LIST OF OVERHAUL MODIFICATIONS WASP R985-AN5 AND AN14B ENGINES

(This EO replaces EO 10A-10AA-6B dated 18 Sep 64)

REWORK OF FRONT CASE AND STUDS ASSEMBLY

INSTALLATION OF HEAVY DUTY PISTON PINS

Figure 1 Rework of Front Case and Stud Assembly, Part 39487 or 109722

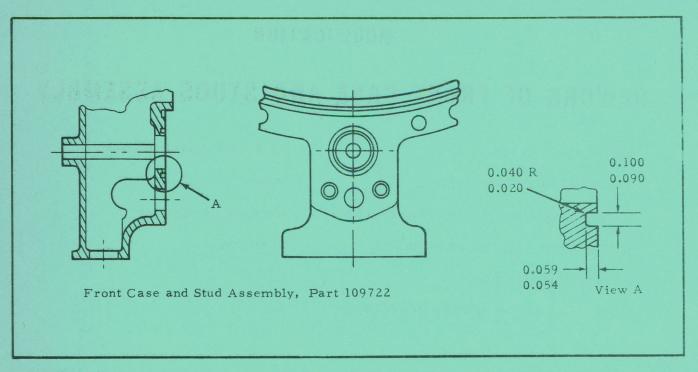
To provide improved sealing at the parting face, between front case and stud assembly and front main crankcase. The front case is reworked to permit the incorporation of a groove around case to crankcase oil drain hole to accommodate an "O"-ring packing.

- This modification will be incorporated as follows:
- At overhaul, rework front case and stud assembly, Part 109722 or 39487, as follows:
- Machine a groove at the location and to the dimensions shown in Figure 1. (1)
- Install "O"-ring packing. (2)
- Identification of Reworked Parts Reworked front case and stud assemblies will be identified by marking /SB1767 after the part number.

Figure 1

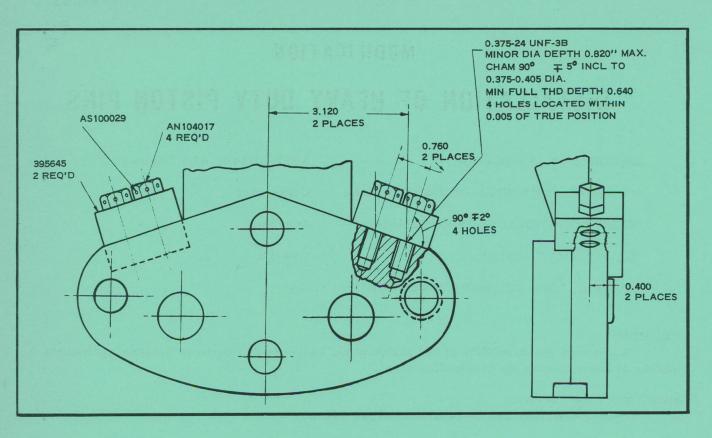
- 2 This modification will be incorporated as follows:
- (a) At overhaul, install a heavy duty piston pin assembly Part 354954, in place of Part 234221 or 31795 in each of the nine pistons in accordance with EO 10A-10AA-3.

When the heavy duty piston pin assemblies are installed, the crankshaft assembly must be reworked to incorporate two compensating counterweights Part 395645, on the front inner cheek, as shown in Figure 1. Lockwire the bolts which secure the counterweights, using AS10029 wire. Incorporation of the counterweights does not require rebalancing of the crankshaft.
